Item 4.**Development Application: 598-610 Crown Street, Surry Hills - D/2023/902**

File No.: D/2023/902

Summary

Figure 32: Section showing the 12m height control dashed

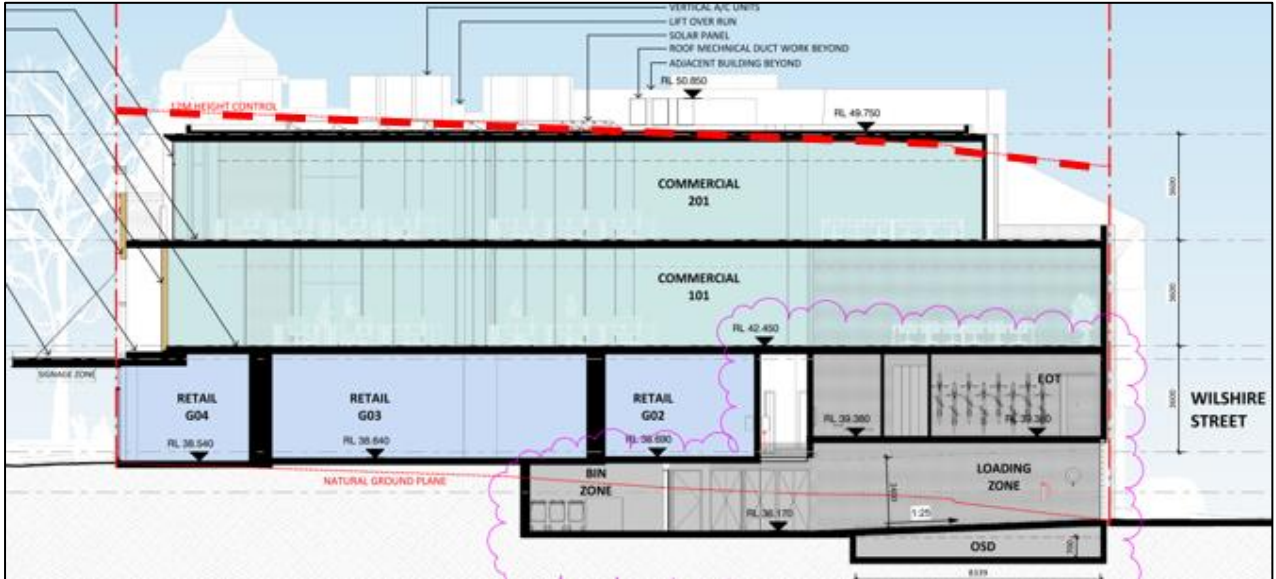
59. The site is subject to a maximum height control of 12m.

60. The proposed development has a maximum height of 13.57m for the new rooftop mechanical plant, resulting in a variation of 1.57m or 13% from the development standard. A maximum height of 12.82m is proposed for the parapet of the north-eastern corner of the roof, which represents a variation of 0.82m or 7% from the development standard.

Figure 33: Height plane diagram showing the portion of the proposal that exceeds the 12m height control

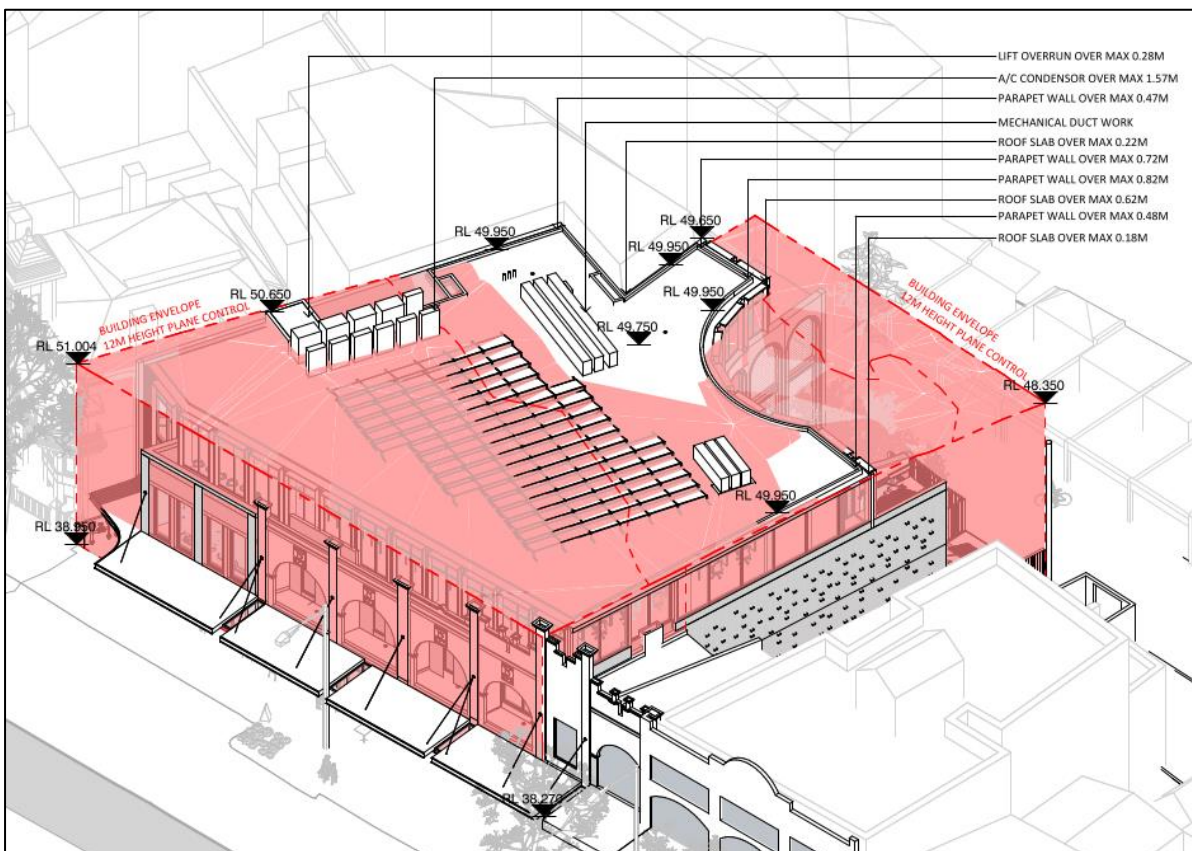
- (b) The portions of the proposed development which breach the height control are mainly rooftop mechanical plant and the lift overrun, and the north-eastern and south-eastern portions of the third storey roof. The proposal generally complies with the three storey DCP height control, and the portions of the third storey roof which breach the 12m LEP standard are a result of the topography of the site falling towards Wilshire St.

Figure 42: Shadow analysis at 2pm mid-winter showing additional shadows in yellow

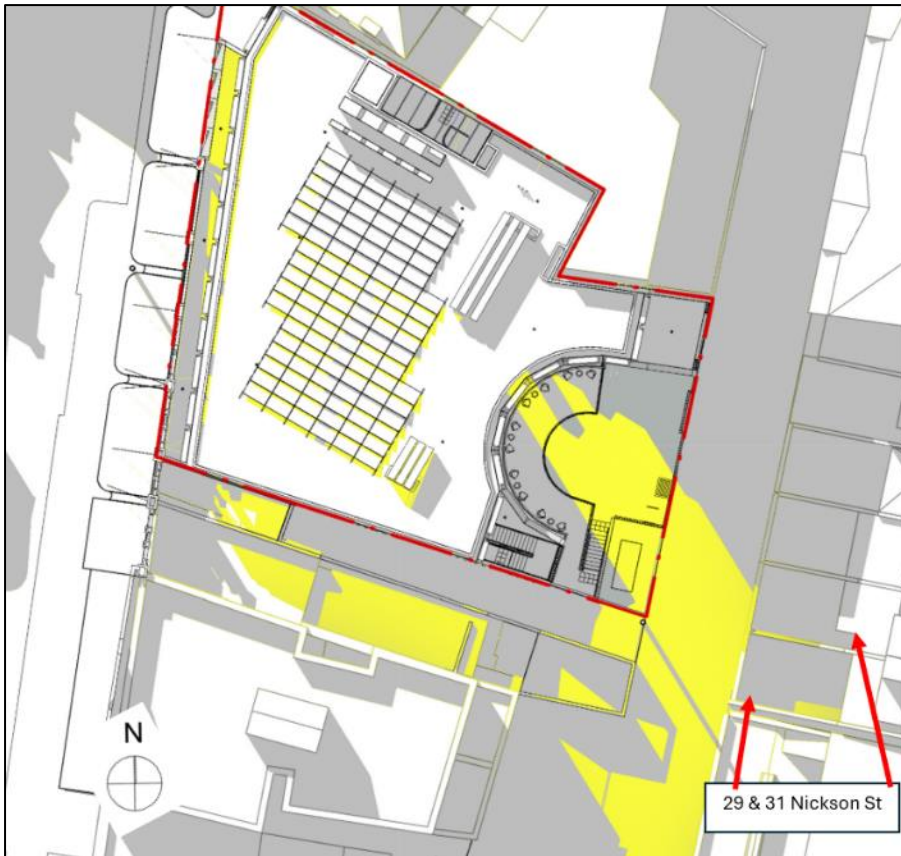
74. Section 4.2.3.1 of the DCP requires that "(2) neighbouring developments must achieve a minimum of 2 hours' direct sunlight between 9am and 3pm on 21 June onto at least 1sqm of living room windows and a minimum 50% of the required minimum area of private open space area" and "(3) *New development must not create any additional overshadowing onto a neighbouring dwelling where that dwelling currently receives less than 2 hours' direct sunlight to habitable rooms and 50% of the private open space between 9am and 3pm on 21 June*".
75. The submitted shadow diagrams indicate that the proposal will create additional overshadowing to the rear private open space of 29 and 31 Nickson St to the south-east between 2pm to 3pm mid-winter. As demonstrated in the below figures, the extent of additional overshadowing to the neighbouring residential properties is relatively minor.

76. The additional overshadowing impacts are considered acceptable, given that the quantum of additional overshadowing to the rear yards of 29 and 31 Nickson St is relatively minor being approximately 2 sqm of additional overshadowing in total from 2pm-3pm mid-winter. It is also noted that the additional shadows at 3pm mid-winter mainly fall over covered areas and rear roofs of 29 and 31 Nickson St, and that these properties are already substantially overshadowed by the existing built form including the apartment building directly to the north at 9-19 Nickson St.
77. As the proposal is considered to be appropriately proportioned and setback from Wilshire St, the additional overshadowing is not considered unreasonable.

Figure 46: Indicative Pre-DA demolition plan showing walls to be retained in solid red

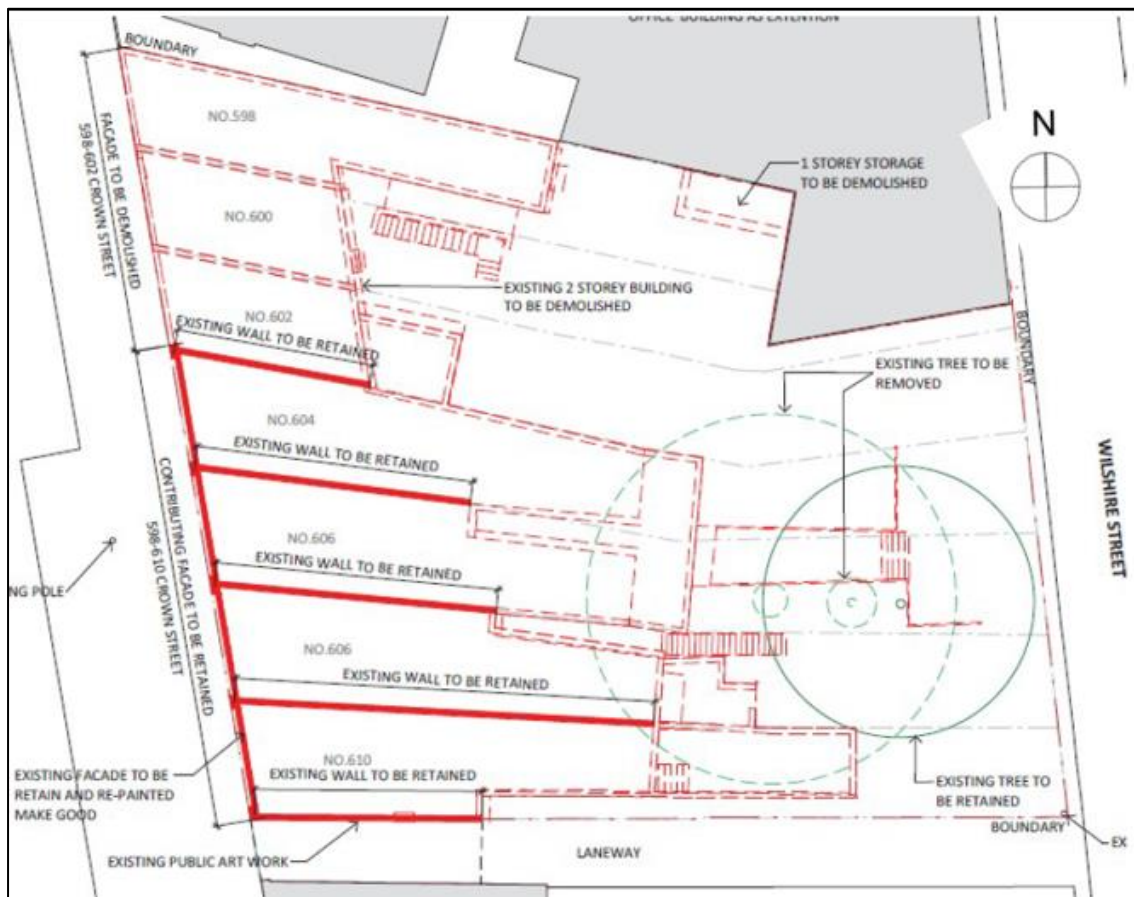
86. The initial pre-DA scheme indicated that the majority of the dividing party walls to the ground floor of the contributory buildings would be retained as shown below.

Figure 52: Perspective of the amended scheme to retain the existing balcony windows and walls of No.604-608 and reinstate the balcony and original windows of No.610

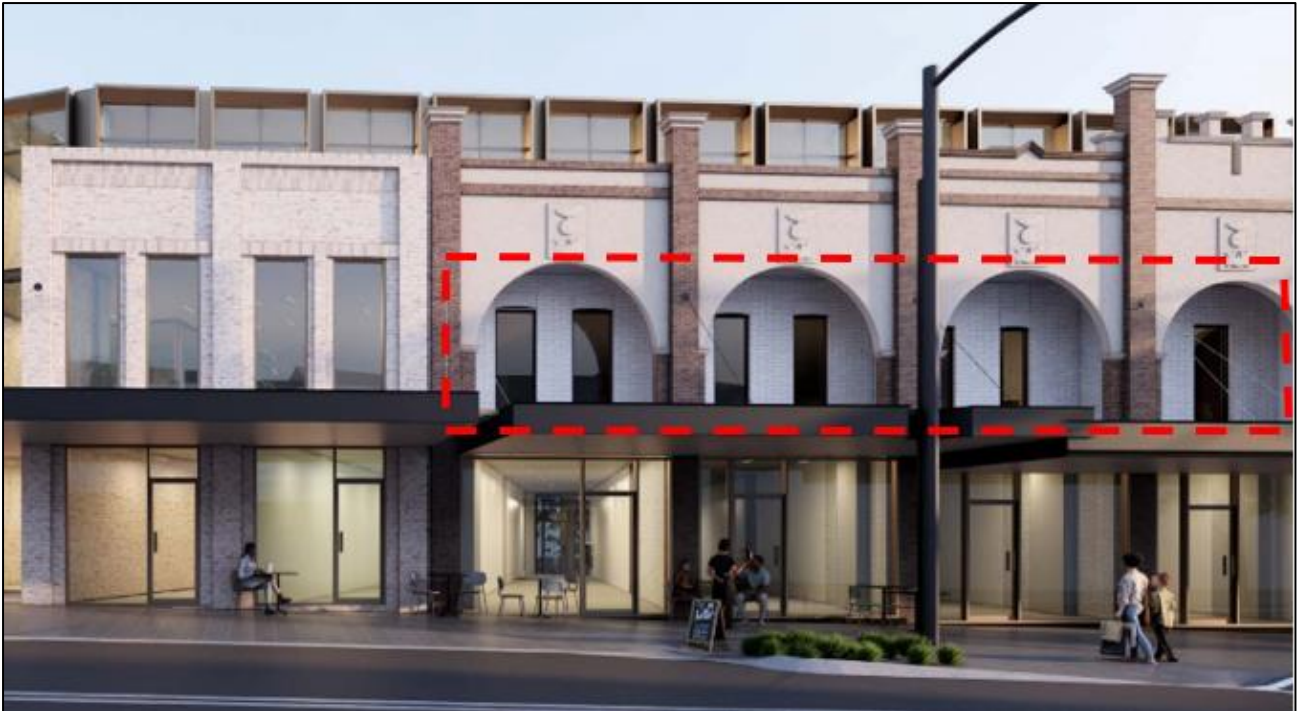
92. Although the amended scheme proposed a greater extent of demolition than the initial pre-DA scheme at ground level, the overall extent of demolition is considered acceptable by Council's Heritage Officer, given that the structural support columns located next to the party walls are being retained, and a greater portion of significant fabric on the first floor, including existing balcony window openings and walls is retained, as well as the retention of the existing ground floor fireplace to No.608. The reinstatement of the original front balcony to No.610 is also supported, as Section 3.9.7 of the DCP requires that "(3) Alterations and additions to a contributory building are to: (d) retain, and where possible reinstate, significant features and building elements, including but not limited to original balconies; and (g) respect the pattern, style and dimensions of original windows and doors".

Figure 53: Proposed Crown St elevation showing the interface between the retained awning (right) and new awning (left)

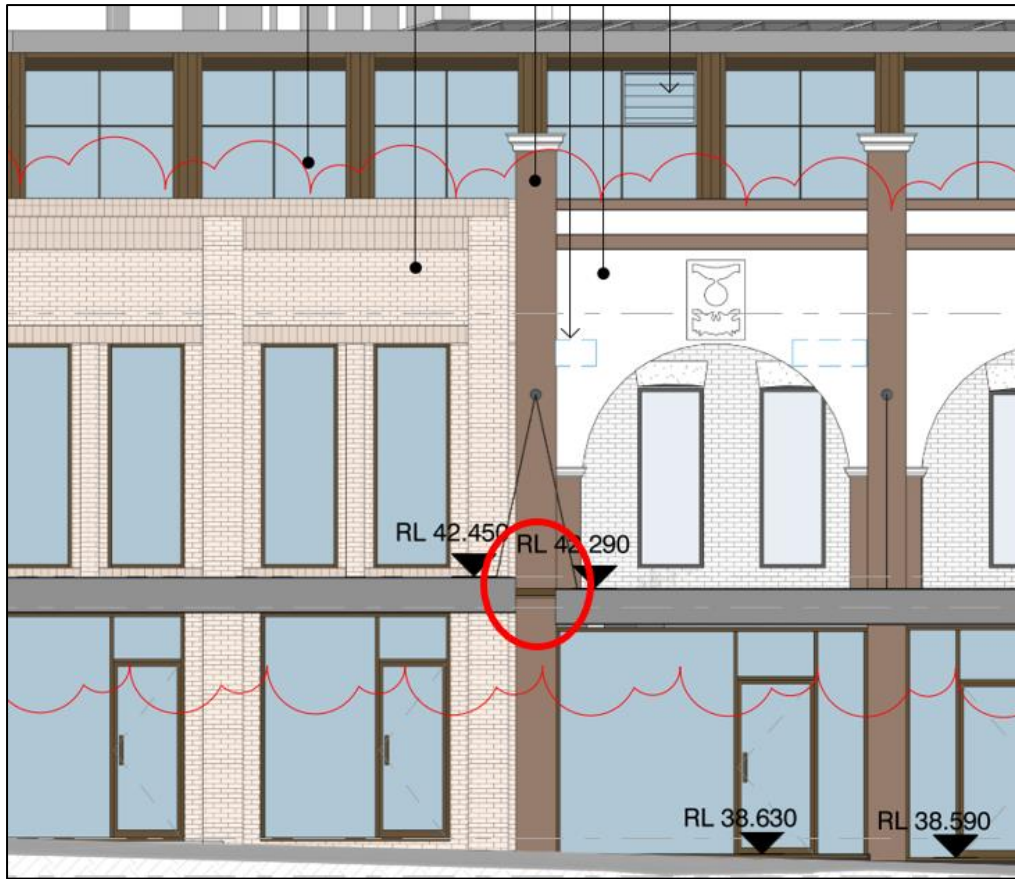
93. The amended proposal also includes the retention of the existing awnings to the contributory buildings, which is supported by Council's Heritage Officer and Urban Designer, as this will preserve the relationship between the existing awnings stepping down with the levels of the site, and the relationship between the existing support rods and the retained facade, noting that part of the southern existing awning is connected to the Council owned laneway structure. However, it is also noted that proposed plans and elevations appear to show a gap and glass insert between part of the retained awning and new infill building awning, on the side of the contributory building. Whereas presently the existing awning extends to the edge of the contributory building.

Figure 58: Detailed section through the infill building showing recommended angled ceilings in green

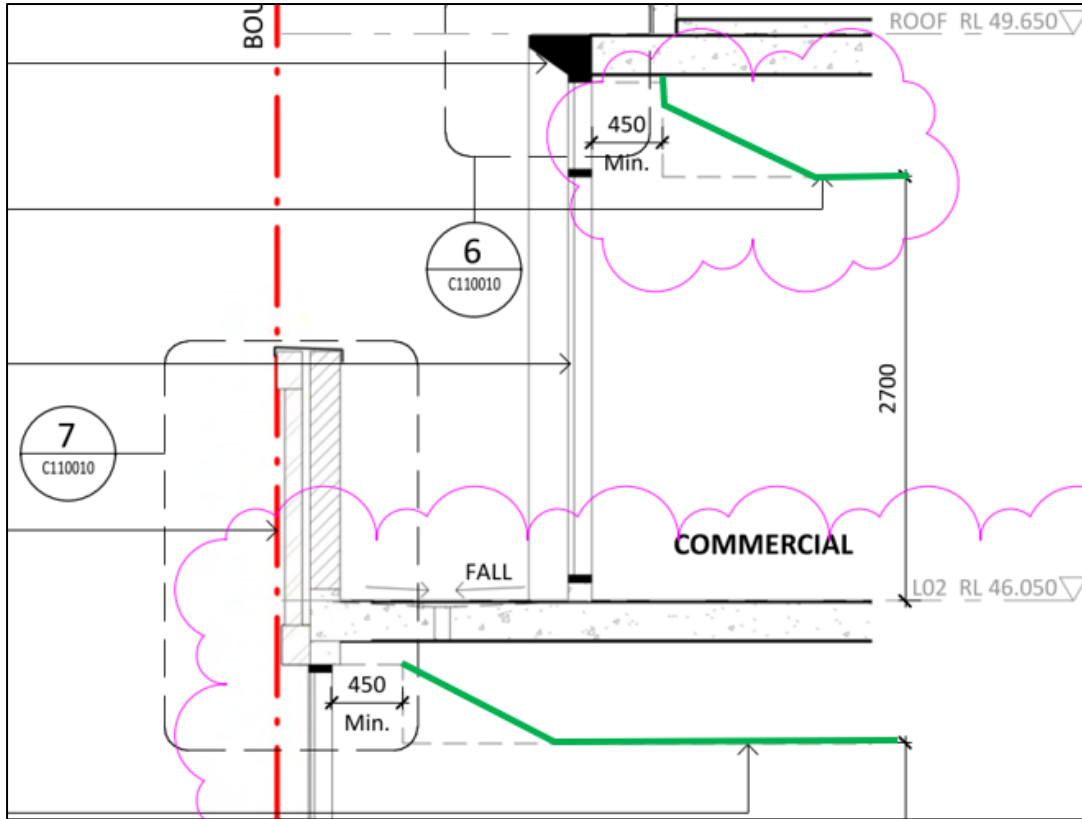
102. During the assessment, concern was raised by Council's Officers that the ceilings of the infill building will be highly visible from the public domain, given the proposed full height glazing and the thickness of the ceilings being approximately 650mm. Although amendments have been made to the design to provide a 450mm separation from the glazing to the edge of the ceiling as demonstrated below, Council's Urban Designer recommends that the interface of the ceiling be angled to further reduce the visual impacts. A condition of consent is recommended for the design of the level 1 and 2 ceilings of the infill building to be angled away from the glazing.
